RE: **6508 Camino Del Oeste NW
Lot 15 Block 2 SAD 228
Volcano Cliffs Subdivision
Grading and Drainage Plan
Engineers Stamp Date 11/26/17 (D10D003G15)**

Based upon the information provided in your submittal received 11/27/17, this plan cannot be approved for Grading Permit until the following comments are addressed.

RE: **Lot 15 Block 2 Volcano Cliffs SAD 228**
6508 Camino Del Oeste NW
Grading and Drainage Plan
Engineers Stamp Date 10/9/17 (D10D003G15)

ENGINEER'S SEAL  11/26/17 DAVID SOULE P.E. #14522	6508 CAMINO DEL OESTE	DRAWN BY WCVJ
	GRADING AND DRAINAGE PLAN	DATE 11-23-17
 1606 CENTRAL AVENUE SE SUITE 201 ALBUQUERQUE, NM 87106 (505) 872-5999		21811-LAYOUT-10-16-17
		SHEET # —
		JOB # 21808

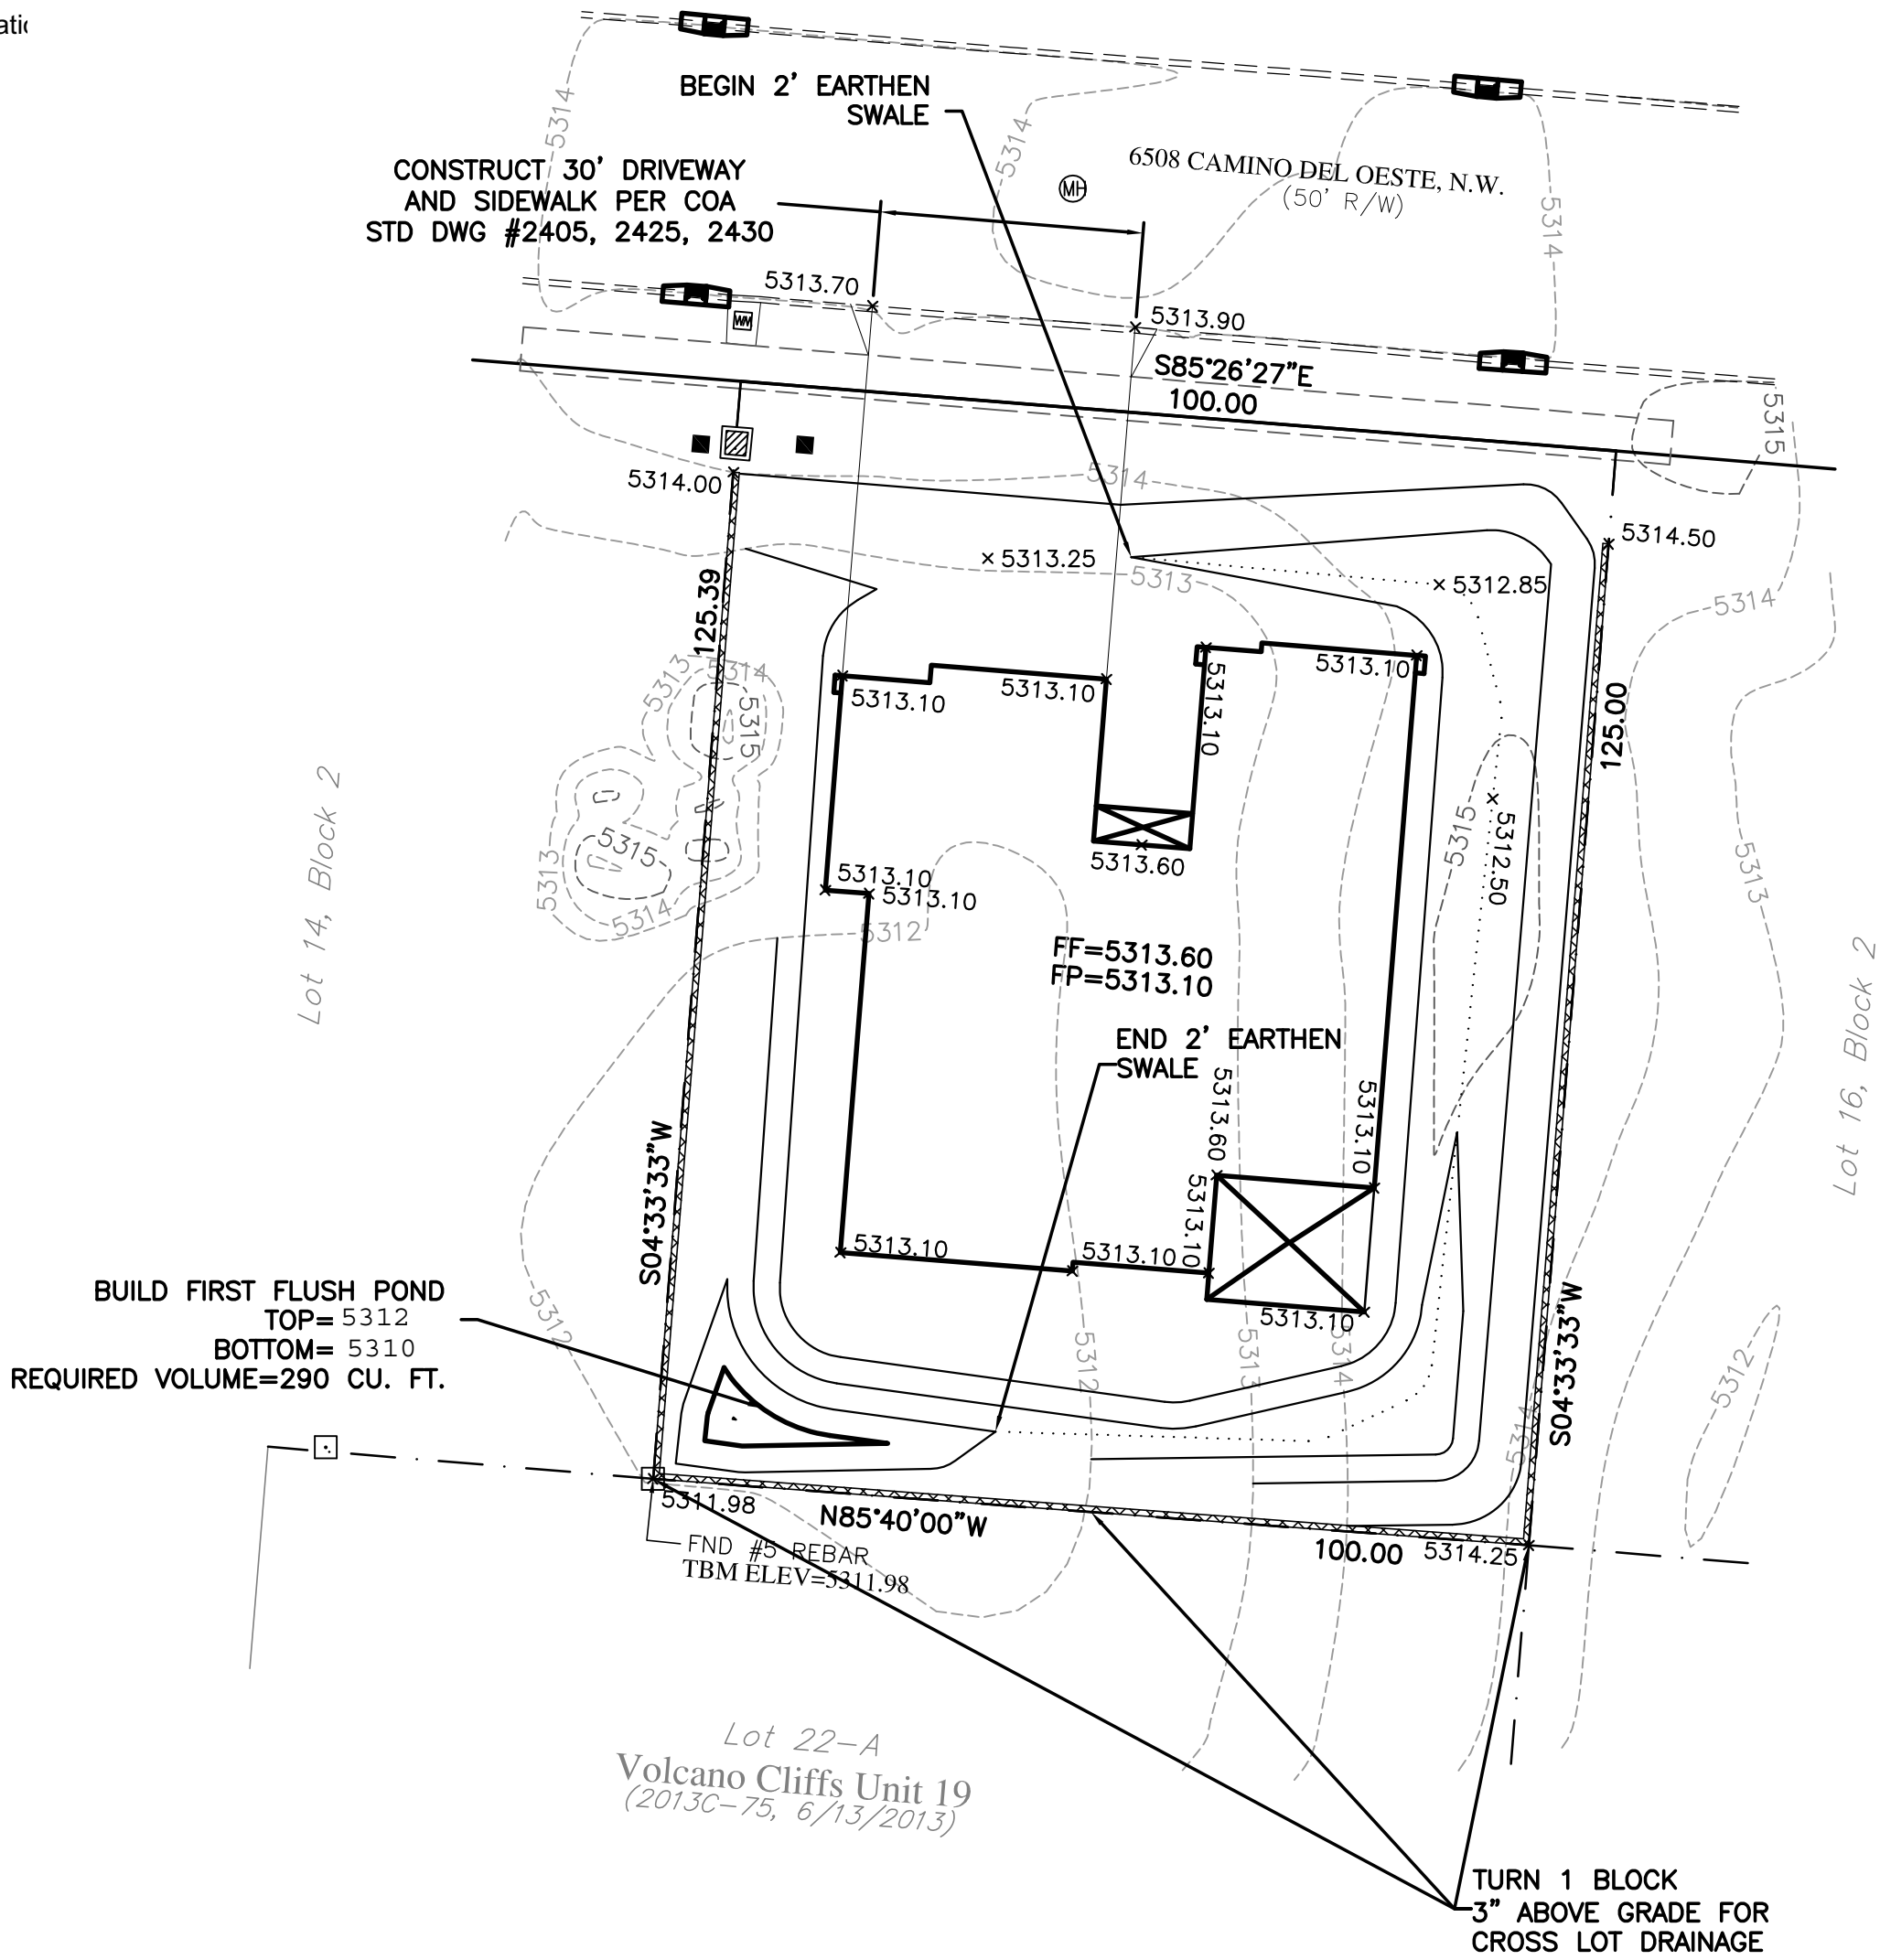
- Show the 10' PUE and the location of the 48" drainage pipe in the PUE on the east side of the property.
- Avoid placing the garden wall in this location, on top of 48" drainage pipe.
